CONTRACT CHANGE ORDER NO. ____
SHEET ____ OF ____

MARK	DATE	DESCRIPTIONS	BY	CH'D	CCO#
4	11/08/11	CABLE RAILING	DT	TH	188
3	10/31/08	BARRIER MODIFICATIONS	GB	TH	44
2	06/13/08	BARRIER MODIFICATIONS	GB	TH	44
1	08/24/07	BARRIER MODIFICATIONS	GB	TH	44

SAN FRANCISCO OAKLAND BAY BRIDGE
EAST SPAN SEISMIC SAFETY PROJECT
SELF-ANCHORED SUSPENSION BRIDGE
(SUPERSTRUCTURE & TOWER)

LUMINAIRE SUPPORT DETAILS NO. 1

ELEVATION
WELDED LUMINAIRE SUPPORT BOX
1:10
(WB Shown, EB Similar) (See Note 12)

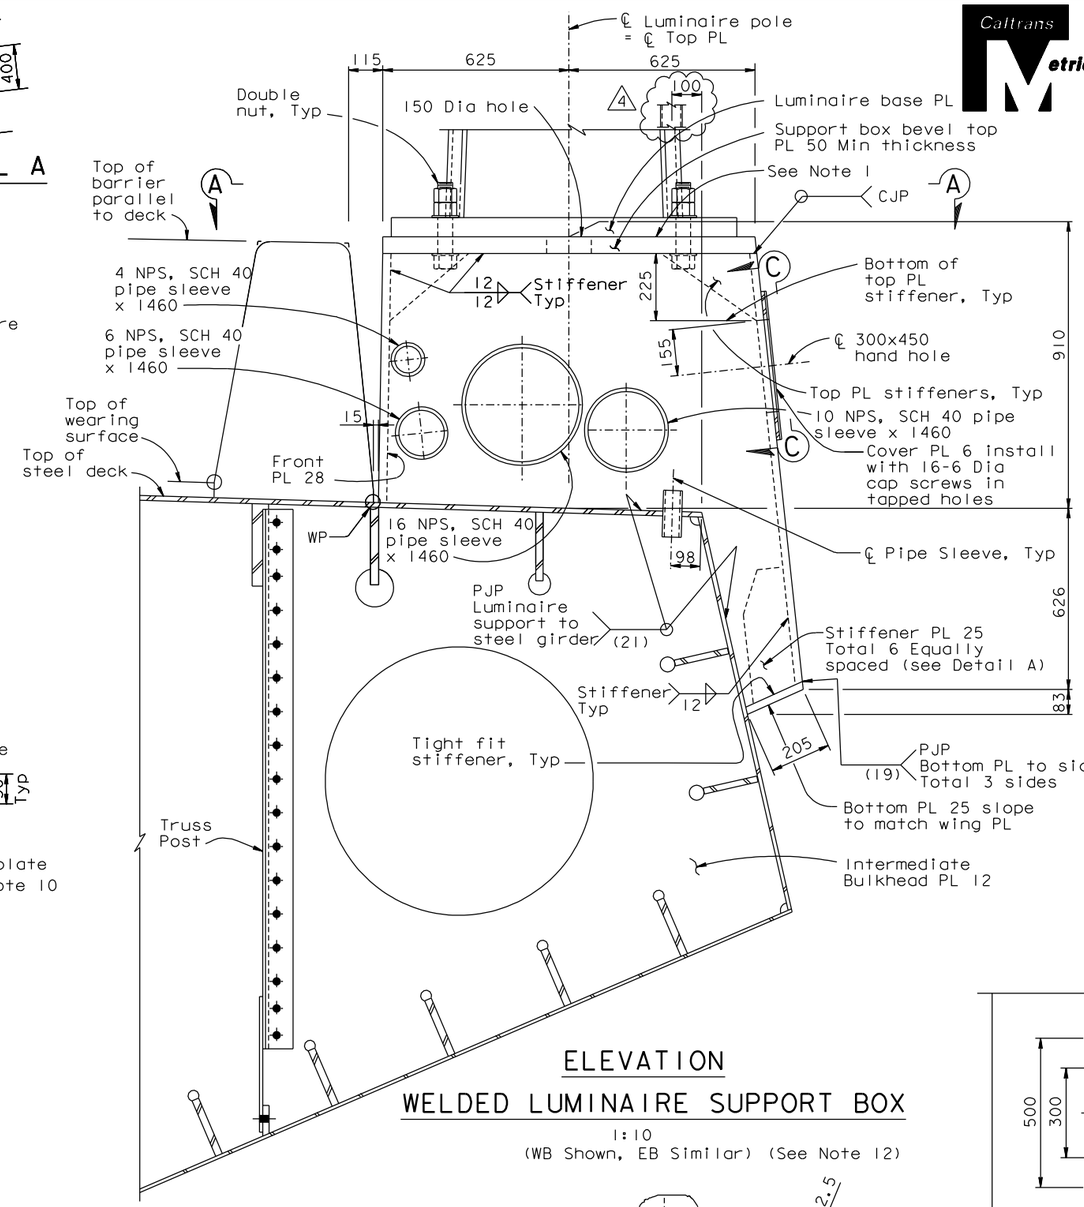
12. At locations where cable railing interferes with luminaire support box, terminate railing at eye bolts, each side of support box, subject to review and approval of the Engineer.
